WHITESTONE HEIGHTS

P-20-01 - Whitestone Heights
Phases 2 and 3

Staff Comments and Stipulations

Project: (P-20-01) Whitestone Heights PH2 and PH3
Request Type: Preliminary Plat
P&Z Date: Jan. 9, 2020

Preliminary Plat

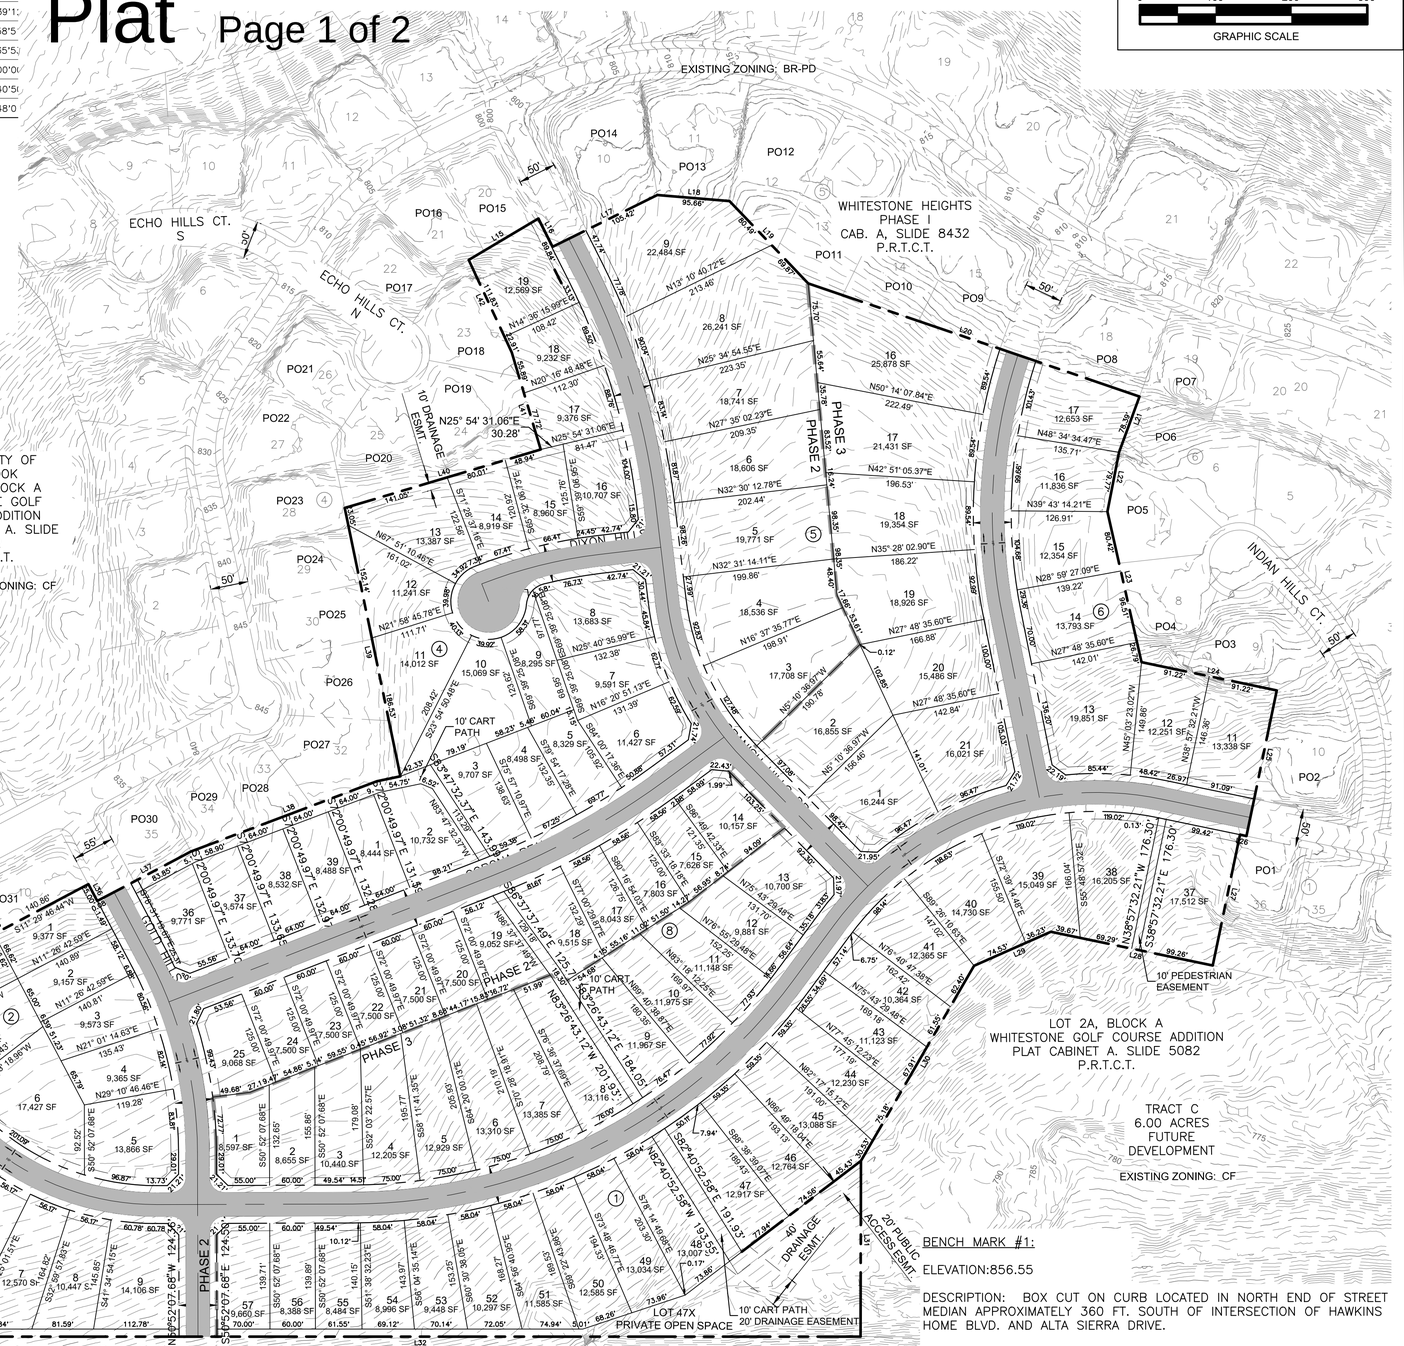
1. Label tracts (i.e. "Tract A", "Tract B", etc.). Identify the purpose of each tract *(16.16.020.B.3.j).*
2. Golf cart path is to be located in a separate tract(s) dedicated to the City and maintained by the golf course. City Council and golf course approval is required to extinguish the existing golf cart path easement and to authorize a new golf cart path alignment.

3. The preliminary plat must show all existing easements, including the golf cart path. The preliminary plat must identify the current golf cart path easement as "to be extinguished" *(16.16.020.B.3.f).*

4. Label the F2 buffer yard on the preliminary plat. An F2 masonry wall (ornamental/textured wall min. 6ft in height) and buffer yard is required when the rear yards and/or side yards of a residential subdivision abut a frontage road, arterial, or collector street (Benbrook Blvd). The screening wall and landscaping should be located in a separate HOA tract, with the wall located to the back of this tract between the landscaping and the residential lots. A minimum of seven and a half feet is required for landscaping *(17.98.030; Table 17.98.030-D).*

5. Corner lots shall be wider than interior lots so that dwellings can be placed further from the street. Corner lots shall be 10% to 20% wider than interior lots; or 6ft to 12ft when interior lots are a minimum of 60ft *(16.16.030.B.6).* Below are lots that may need to be widened:

a. Block 7 Lot 9
    b. Block 1 Lot 57
    c. Block 8 Lots 1, 13, 14, 25
    d. Block 4 Lots 6, 8, 16, 36
    e. Block 5 Lots 1, 21
    f. Block 6 Lot 13

g. Block 2 Lot 5
6. Verify interior lots are a minimum of 60ft in width, measured at the front build line. The lot width is the distance between straight lines connecting front and rear lot lines at each side of the lot, measured across the rear of the required front yard, provided that the width between side lot lines at their foremost points (where they intersect with the street line) shall not be less than 80% of the required lot width except in the case of lots

1. Add a note to the plat stating that Lot-to-Lot drainage is prohibited without a drainage easement *(16.28.030.B.7).*
2. Add a note to the plat stating that the City of Benbrook is not responsible for the surface maintenance of drainage easements. Surface maintenance of drainage easements is the responsibility of the property owner *(16.28.020.A and 16.28.035).*

3. Provide a 10' Drainage Easement along the northwest side of Lot 17, Block 6 due to the existing drainage from Lot 6, Block 6 *(16.28.030.B.7, 16.28.020.A, and 16.28.035)*.

4. Provide 10' Drainage Easements through Lots 2 & 3, Block 7 to accept future, allowable surface drainage from the commercial Tract 2A07 *(16.28.030.B.7, 16.28.020.A, and 16.28.035).*

5. Portions of Lots 36 to 39, Block 4 drain to the Cart Path tract. A drainage easement will be required on the cart path tract for any individual lots that drain to the Cart Path tract *(16.28.030.B.7)*.

8. Exhibit 3-1 shows floodplain being created by this development so a LOMR will need to be submitted to FEMA for approval *(15.40.330.I).* The floodplain needs to be shown on the plat.

9. The headings on HEC-HMS Global Summary Tables overlap and are difficult to read.
10. The City is implementing an Erosion Hazard Zone (EHZ) along channels, ditches, etc. The EHZ's starting point is at the toe of the channel, ditch, etc., then take a 4:1 slope up to ground level. The first 60% of the EHZ starting at the channel is a no development zone and the remaining 40% of the EHZ is limited development. Please put the EHZ on the plat and maps *(15.42.040.D.12).*
